1st Floor Plan-SUITE 118 - LAUREL(MOD.) - 2J+D-P

CONSTRUCTION SUMMARY

Hampton Place

LOT NUMBER	PHASE	HOUSE TYPE	CLOSING DATE
118	1	LAUREL*	11-Sep-18

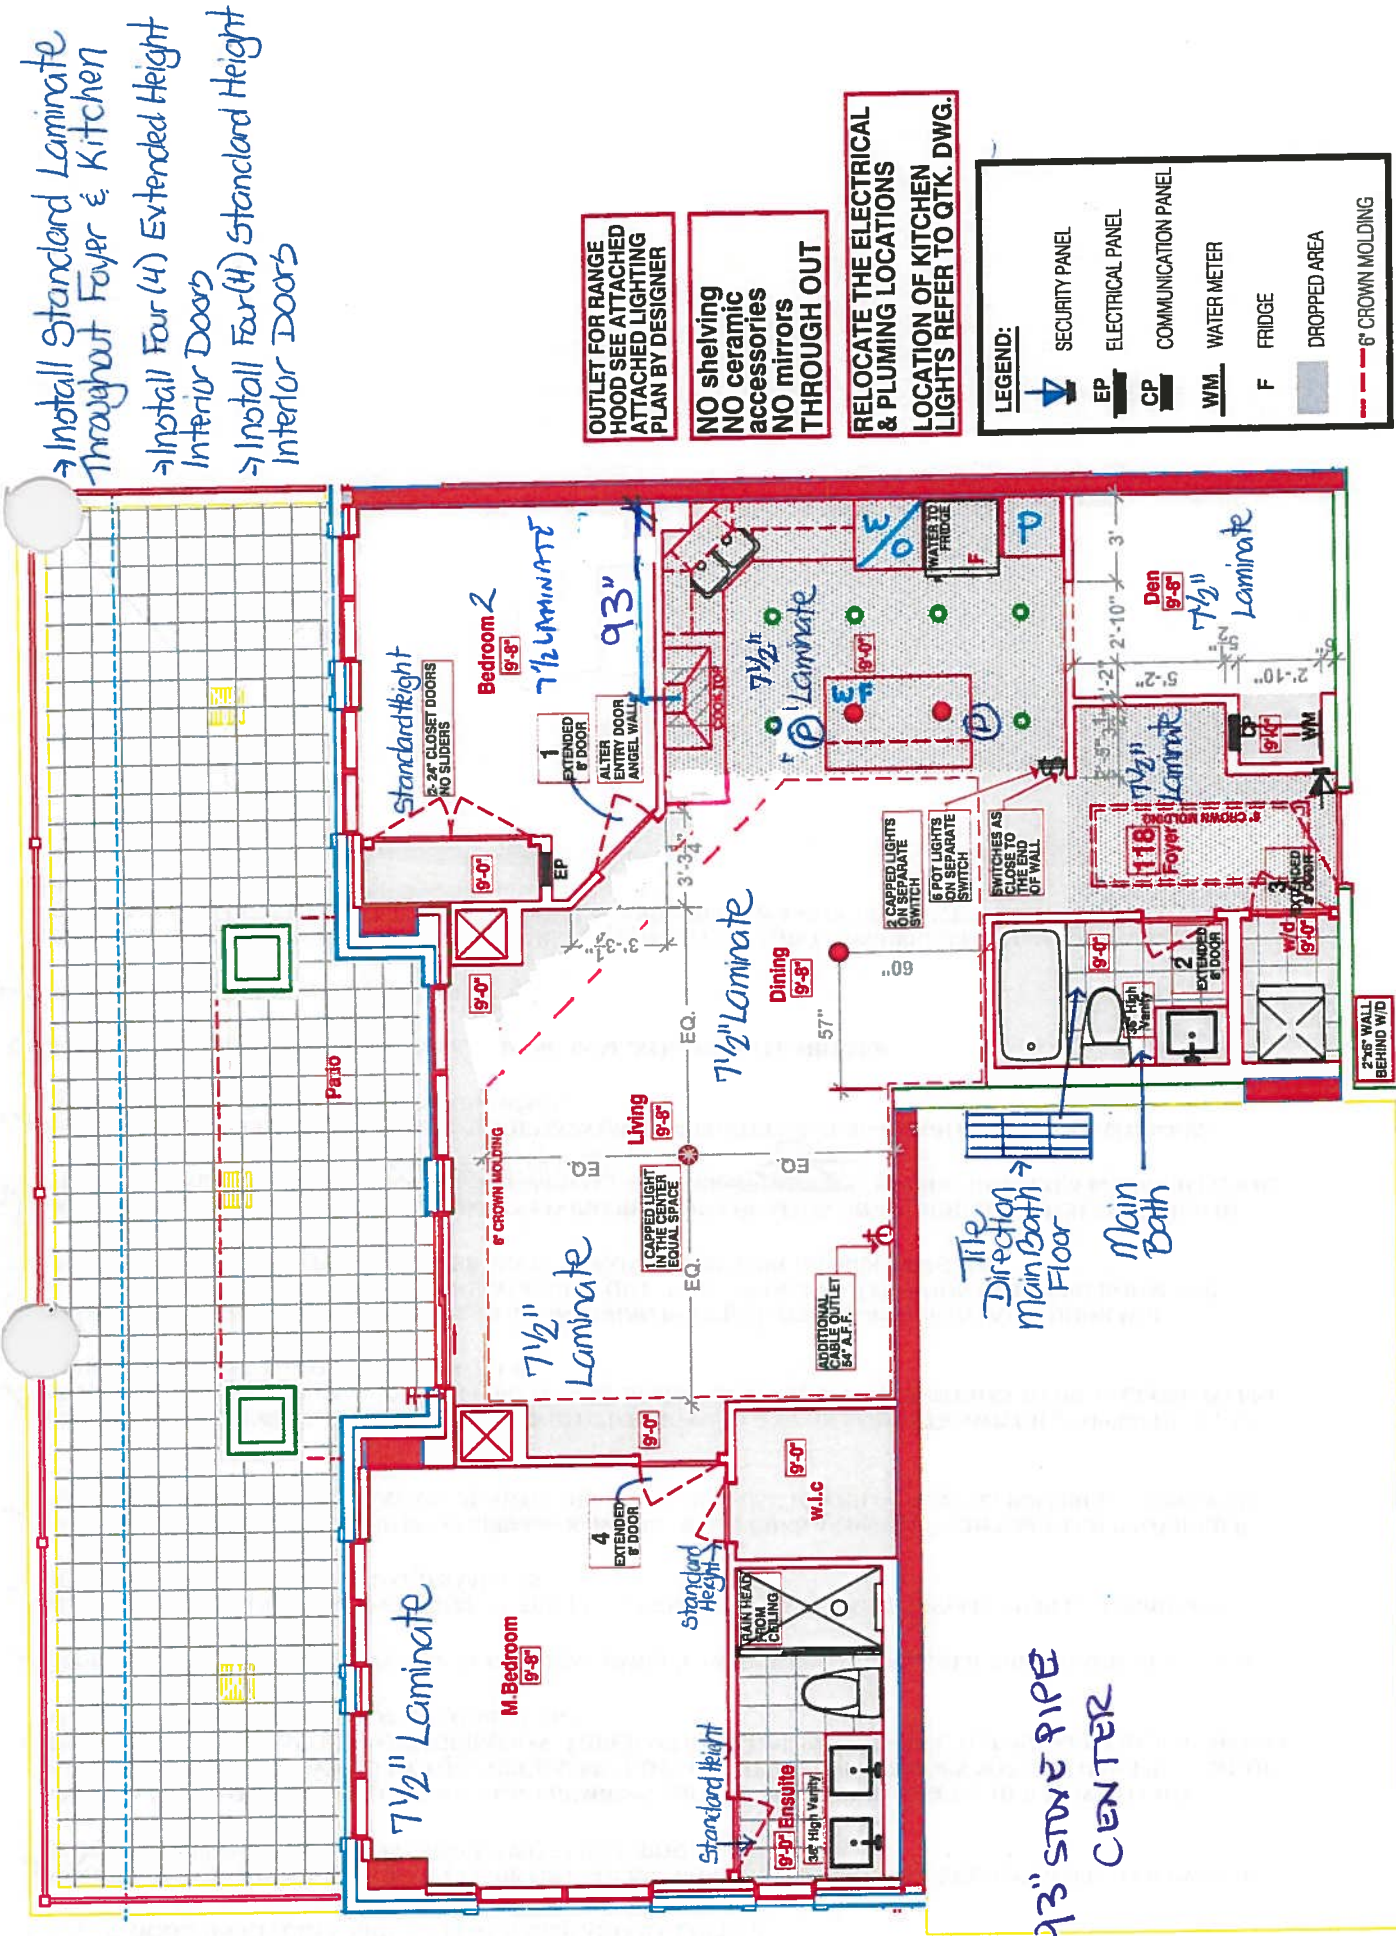
KITCHEN.

- CHIMNEY STOVE PIPE CENTER 60"
- WIRING FOR FUTURE WINE FRIDGE IN ISLAND
- 2x = PLUGS IN ISLAND
- 2x = PENDANT LIGHTS OVER ISLAND
- 6x = POT LIGHTS IN KITCHEN.
- 5x - PUCK LIGHTS UPERS
- 5x - PUCK LIGHTS LOWERS.
- UPGRADE APPLIANCE PACKAGE 3'A" with SPECIM FRIDGE
- MAIN + ENSUITE BATH RANSO 36 1/4" VANITIES w/ 3" SPLASH.
- UPGRADE KITCHEN.

CLIENT: ROYAL PINE HOMES	JOB NAME: UNIT 118 HMP	ROOM: KITCHEN	DRAWN BY: SK
SITE: HAMPTON PLACE	DOOR STYLE: —	DOOR HANDLE: —	SCALE: 1/2"=1'-0"
PHONE: —	FINISH: —	DRW HANDLE: —	DATE: DEC 14, 2017
EMAIL: —	SPECIES: —	TOP: —	PAGE: —

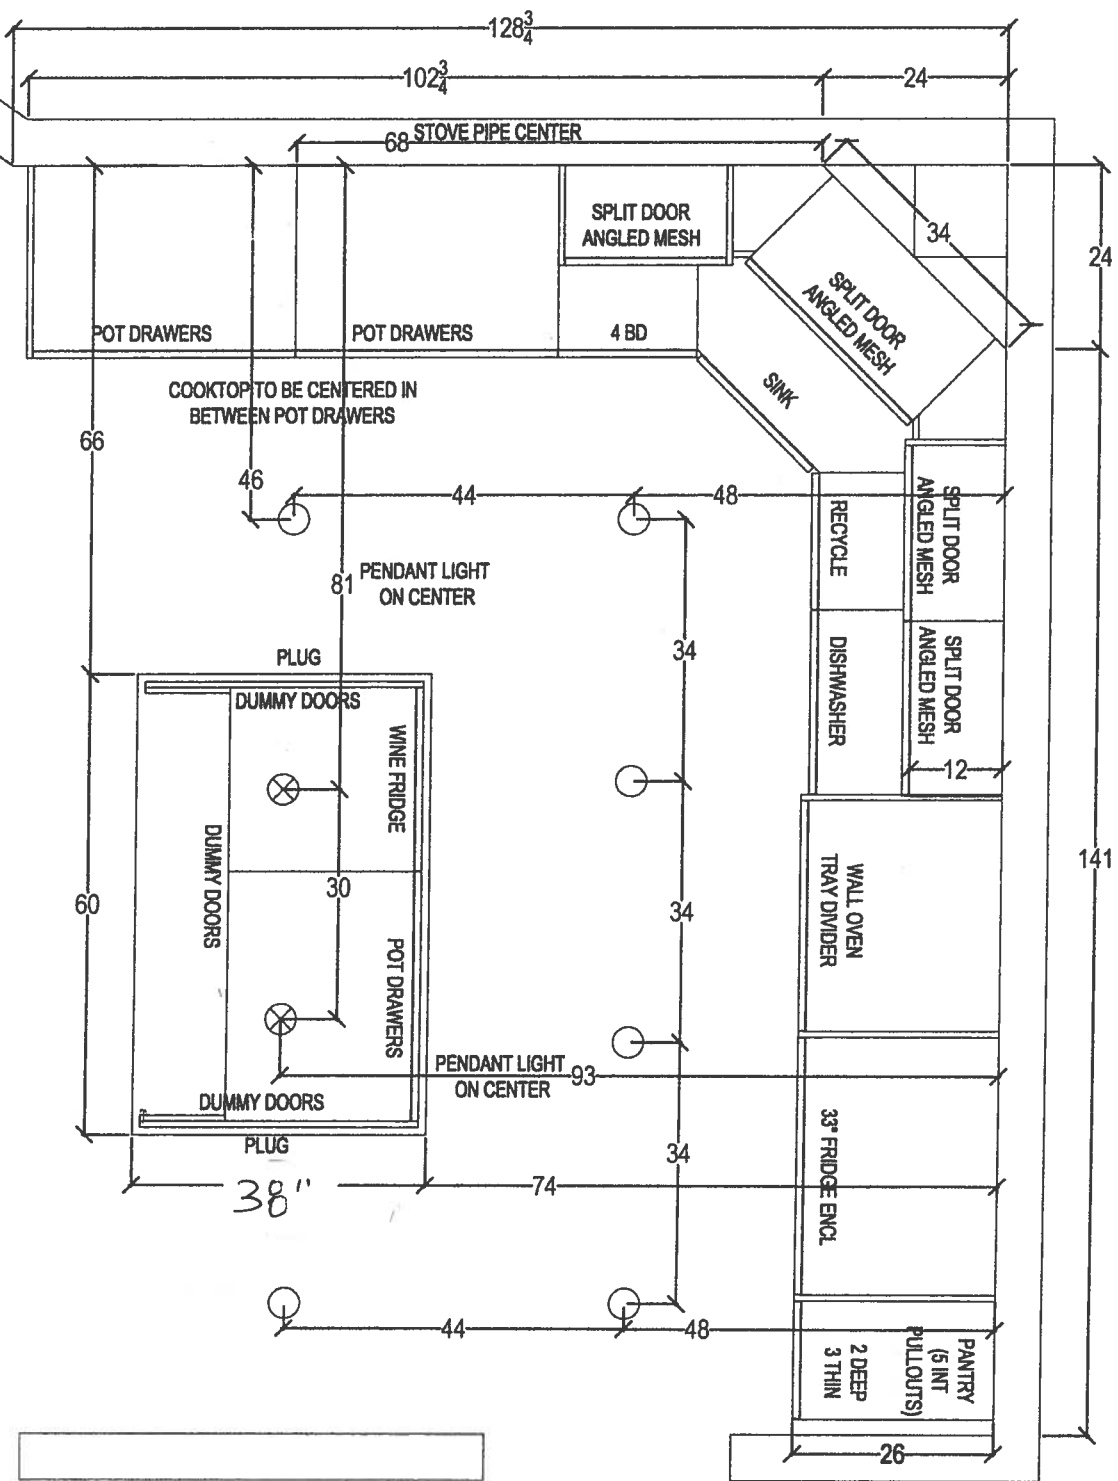
ENTIRE CEILING IN THE KITCHEN
IS DROPPED

CLIENT: ROYAL PINE HOMES		JOB NAME: UNIT 118 HMP	ROOM:	VANITIES	DRAWN BY: SK	COMMENTS:
SITE: HAMPTON PLACE		DOOR STYLE: —	DOOR HANDLE: —		SCALE: 1/2" = 1' - 0"	
PHONE: —		FINISH: —	DRW HANDLE: —		DATE: NOV 15, 2017	
EMAIL: —		SPECIES: —	TOP: —		PAGE: —

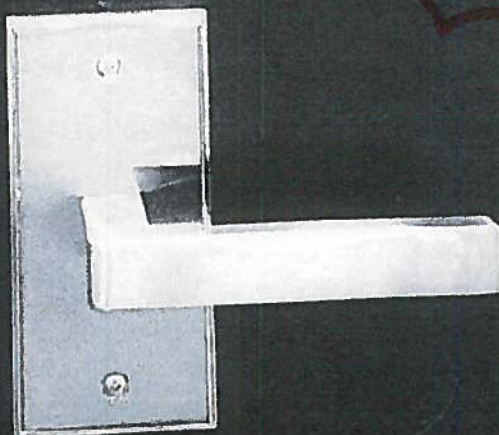
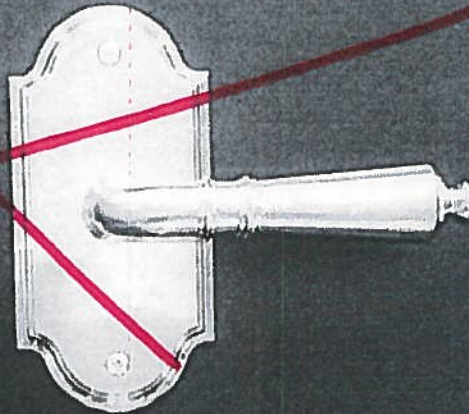
** Raised Vanities + 3" Splash **

Master Ensuite
Shower stall

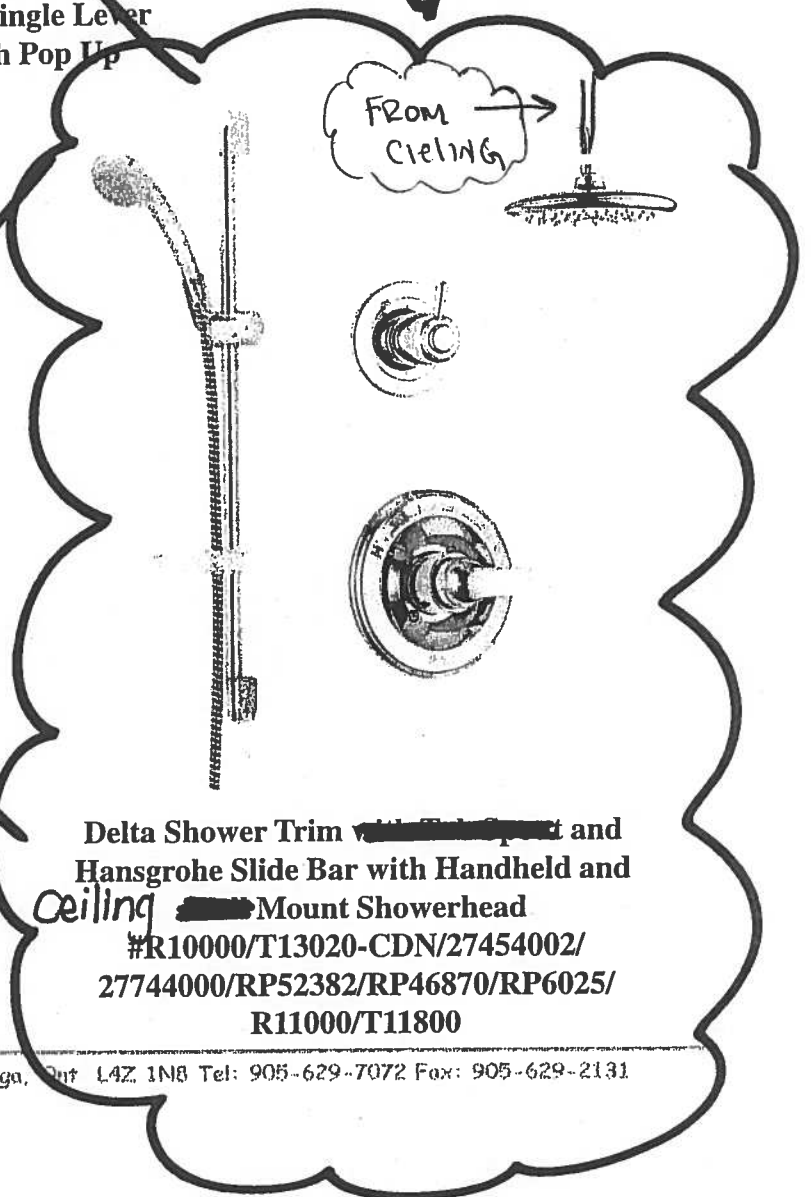
Delta Shower Trim with Tub Spout and
Hansgrohe Slide Bar with Handheld and
Ceiling Mount Showerhead
#R10000/T13020-CDN/27454002/
27744000/RP52382/RP46870/RP6025/
R11000/T11800
